November 8, 2001
GO2-01-153

Subject: **COLUMBIA GENERATING STATION, OPERATING LICENSE NPF-21
REQUEST FOR ADDITIONAL INFORMATION REGARDING THE
UNISOLABLE DRAIN LINE BETWEEN THE CONTROL ROD
DRIVE/CONDENSATE PUMP AND REACTOR CORE ISOLATION
COOLING PUMP ROOMS**

REQUEST FOR ADDITIONAL INFORMATION ATTACHMENT

FLOODING EVENT	
SENSITIVITY CASE 1 [SW-A FAILURE]	
AUTHOR _____	DATE _____
REVIEWER _____	DATE _____

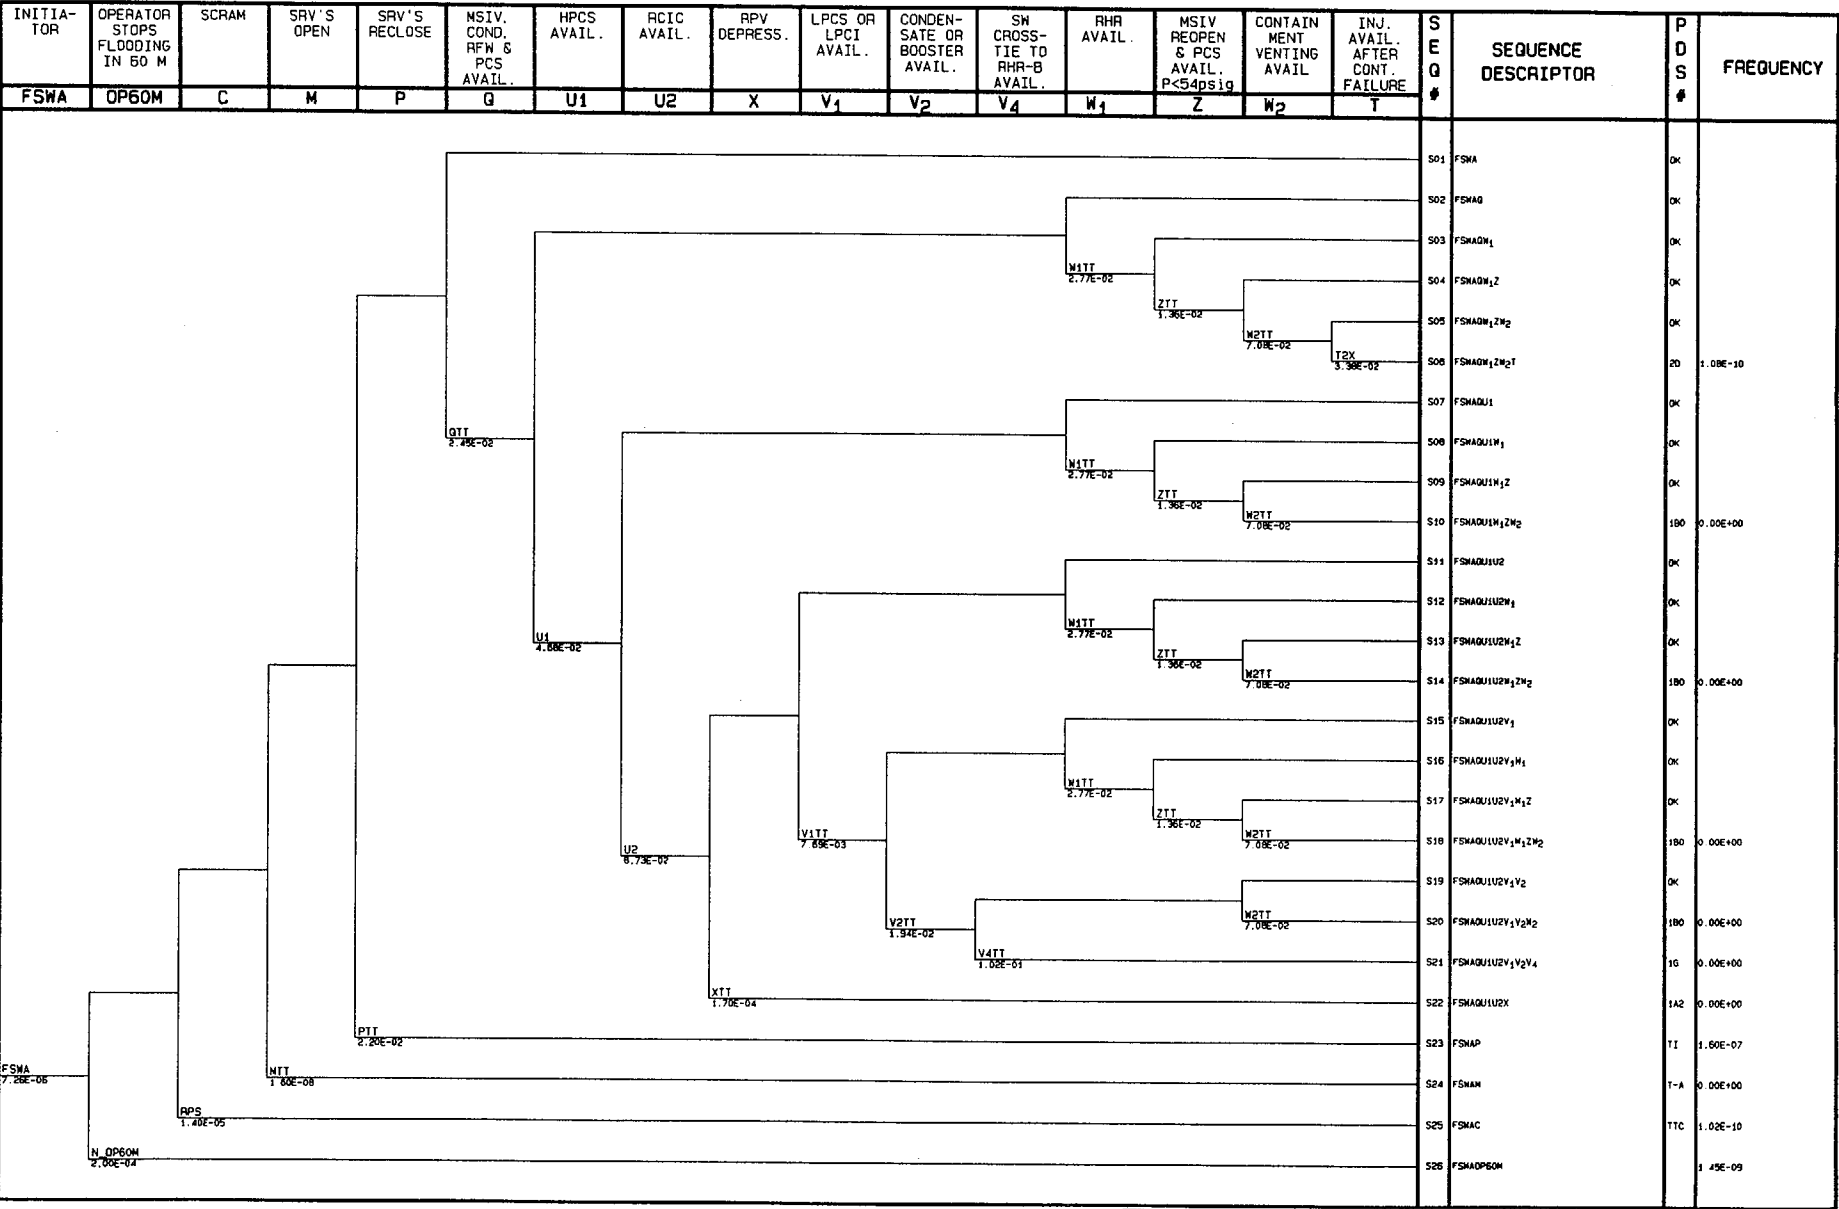
Please provide the risk analysis including assumptions used to determine that the increase in core damage frequency is less than $1\text{E-}10$.

The event trees are initially quantified assuming that flooding does not result in RCIC failure (i.e., the EDR drain line does not allow floodwater flow to spread from the CRD/COND pump room to the RCIC pump room). Results from these event tree analyses are provided in Table 1 as Cases 1, 2, and 3 (results are expressed in terms of CDF). The event trees are re-quantified

assuming an additional loss of RCIC due to flooding from the CRD/COND pump room through the unisolable EDR drain line. Results from these event tree analyses are provided in Table 1 as Cases 1R, 2R, and 3R. The analysis assumes if plant operators could not terminate flooding within one hour, then core damage would occur. The pipe rupture frequency was calculated based on the methodology of EGG-SSRE-9639, "Component External Leakage and Rupture Frequency Estimates," November 1991. The impact of the unisolable EDR drain line on CDF is obtained by summing the differences from each scenario [i.e., (Case 1R - Case 1) + (Case 2R - Case 2) + (Case 3R - Case 3)]. The event trees for each quantified and re-quantified scenario are provided following Table 1.

U:\OLD_PCVE_DRIVE\RV3_1130\ET\FSWA.EVT 10:27:30am 12-02-99 NUPRA 2.33 WNP-2
Quantification Date: 12-02-99 9:27:31am TOTAL CMF = 1.56E-009
